# Access Compliance Report

## Public Rights-of-Way

### (Curb Ramps)

Intersection ID: N/A	Main Street: HUNTING BIRDS LN	Cross Street: LONG TALON WY	Location: NW
ADA ID: 2653104627DE	Ramp Type: PerpDiag	Initial Pass/Fail: Fail	Overall Compliance: No
		Severity Score: 10

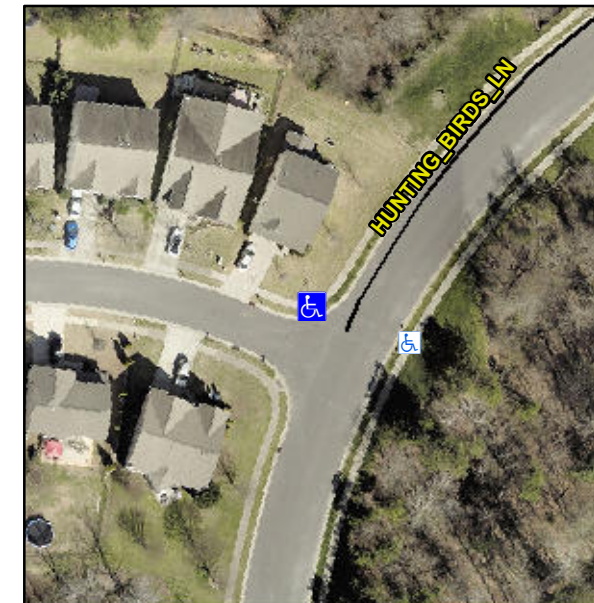
**Not Found, R304.5.1, R304.5.3**

Compliance	Description	Data	Compliance	Description	Data
N/A	Ramp Length (in)	47.0	Yes	Ramp Slope (%)	5.4
No	Ramp Width (in)	44.0	No	Ramp XSlope (%)	3.0
N/A	Flare Type LT	N/A	N/A	Flare Type RT	N/A
N/A	Flare Slope LT (%)	N/A	N/A	Flare Slope RT (%)	N/A
N/A	Flare Traversable LT?	N/A	N/A	Flare Traversable RT?	N/A
N/A	Landing Length (in)	N/A	N/A	DWS Provided?	N/A
N/A	Landing Width (in)	N/A	N/A	DWS Contrast?	N/A
N/A	Landing Slope (%)	N/A	N/A	DWS Length (in)	N/A
N/A	Landing X Slope (%)	N/A	N/A	DWS Full Width?	N/A
N/A	Landing Curb? (Y/N)	N/A	N/A	DWS Offset (in)	N/A
N/A	Shared Landing?	N/A			
N/A	Gutter Ponding?	N/A	N/A	Gutter Slope (%)	N/A
N/A	Gutter Lip Ht (in)	N/A	N/A	Gutter X Slope (%)	N/A
N/A	Painted X Walk1?	No	N/A	Painted X Walk2?	No
	X Walk 1 Direction	To SW		X Walk 2 Direction	To SE
N/A	X Walk 1 Width (in)	N/A	N/A	X Walk 2 Width (in)	N/A
	X Walk 1 Slope (%)	4.2		X Walk 2 Slope (%)	1.4
	X Walk 1 X Slope (%)	1.2		X Walk 2 X Slope (%)	1.9

**Remove & Replace Curb Ramp With Two New Directional Ramps or Equivalent.**
